MSP430FG43x Device Erratasheet

Current Version

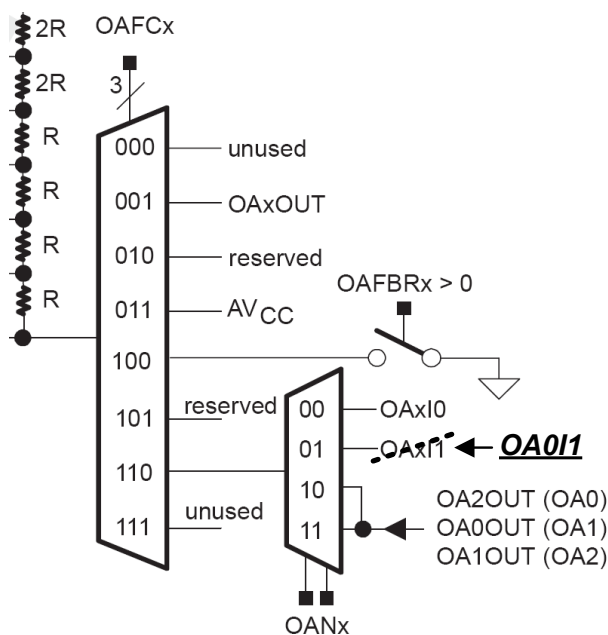
Module: OA, Function: OAx11 input selection

Referring to the OA block diagram in the MSP430x4xx User's Guide, the internal connection of the OAx11 input to the OAFc mux is incorrect. The signal input to the OAFc mux when OANx = 01 is OA011 for all OAs. See the figure below for a graphical representation:

Workaround:

None
